SIB 52 04 19

SECOND ROW 60/40 DRIVERS SIDE SEAT INTERMITTENTLY WON'T LATCH

This Service Information Bulletin (Revision 4) replaces SI B52 04 19 **dated August 2019**.

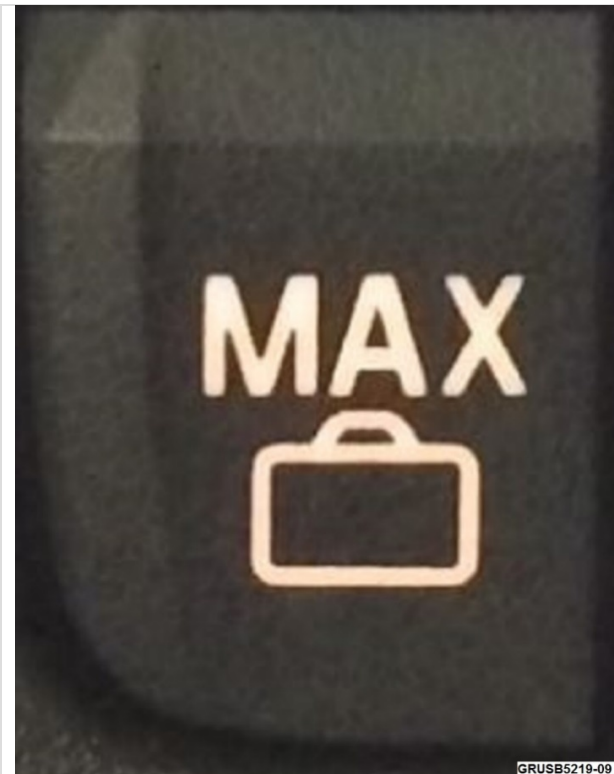
<p>As of March 2019 production, two machined washers (shown) were added to the bottom of the inner seat rail on the driver's side (left rear) of the 60/40 split 2nd row seat.</p>
--	---

For vehicles with this specific complaint that were produced prior to March 2019, a comparable correction is to add two 2mm thick flat washers in this location.

The washers must have

- 2 mm thickness
- 15 mm inner diameter hole for the bolt fitment
- Outside diameter must be at least 30 mm

- Recommended basic surface coating for rust protection

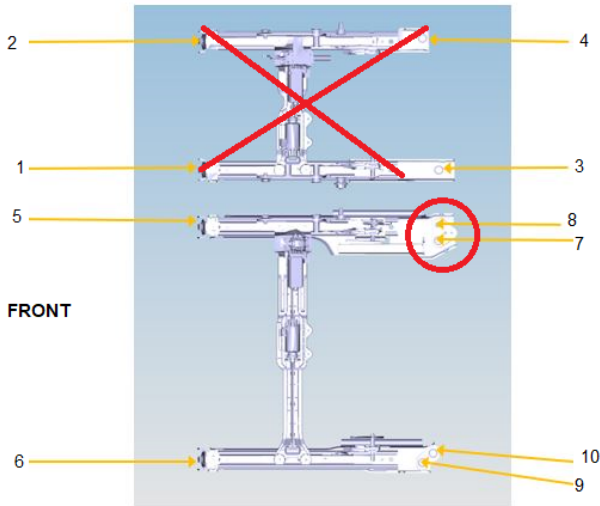
5. Install 2 flat 2 mm thick washers under rear of inner rail of the 60% structure (circled).

Washers are installed between the floor of vehicle and the rear of the inner seat rail.

Note: Only install the 2 washers at the specified location 7 / 8 (circled).

- Only install washers at the specified location
- Seat must ***NOT*** be in easy entry position during the fastener torquing.
- Seat must ***NOT*** be fully forward when torquing the fasteners

- Locations 1 thru 4 pertain to the 40% 2nd row seat which is not affected by this repair

6. Tighten all fasteners to 42 Nm following the torque sequences #5 thru 10.
